As a visitor to Stockton please accept this submission of objection regarding Incitec Pivot's proposed ammonium nitrate plant on Kooragang Island (SSD-4986).

Figures 2 and 3: Stockton Monitoring Station PM10 and PM2.5 Graphs

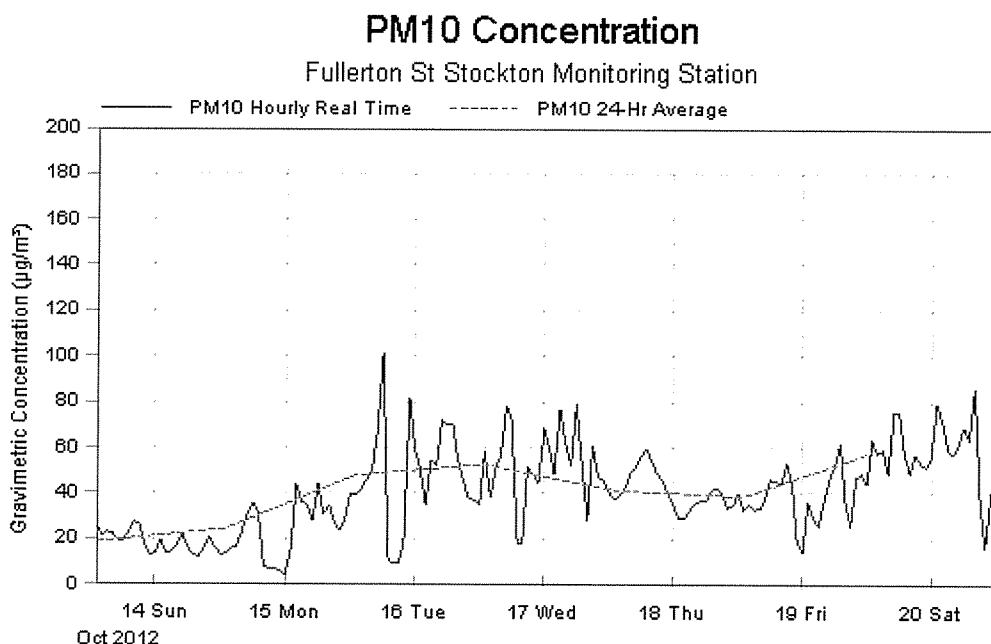
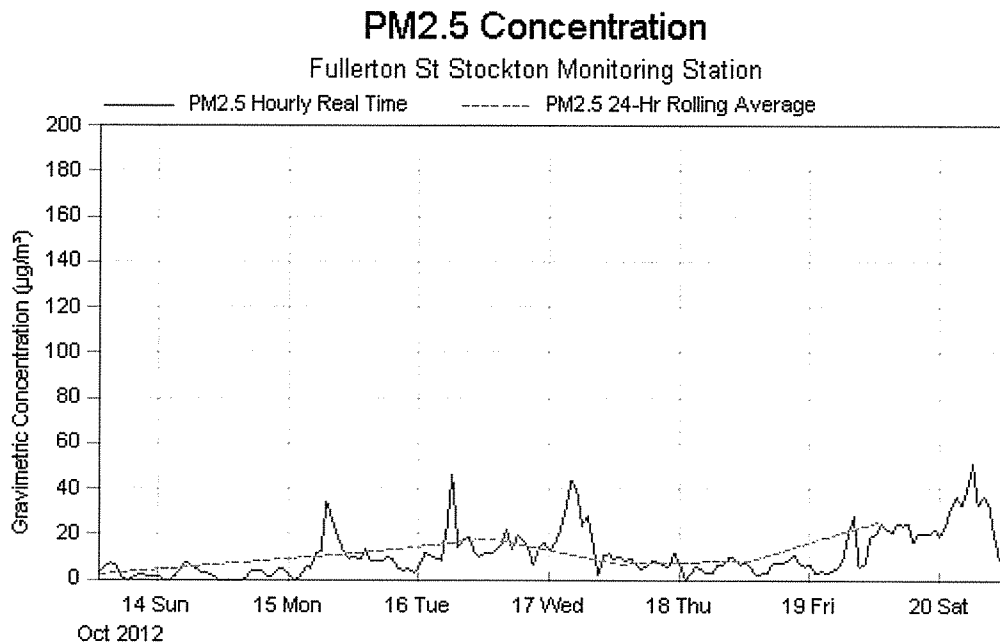
From air quality data from Orica's monitoring sites including the latest continuous monitoring station at Stockton show that already fine particles are at dangerous levels (Figure 2 and 3).

Despite the station having only operated for a week there is a worrying trend in particle levels. Currently after one week the 24 hr rolling average for:

- PM 10 is 57.9 ug/m³ and above the NEPM standard of 50 ug/m³ with a maximum 1 hr value 100 ug/m³
- PM_{2.5} is 26.5 ug/m³ above the target value of 25 ug/m³ with a maximum 1 hr value 50 ug/m³

A trend is evident with PM 10 and PM 2.5 particles increasing significantly as soon as the wind direction turns into a direction between west and north which brings pollution from Kooragang Island onto Stockton. These results are troubling to the community and this further indicates the need to reduce fine particles in Stockton rather than adding further fine particle pollution with the proposed Incitec plant.
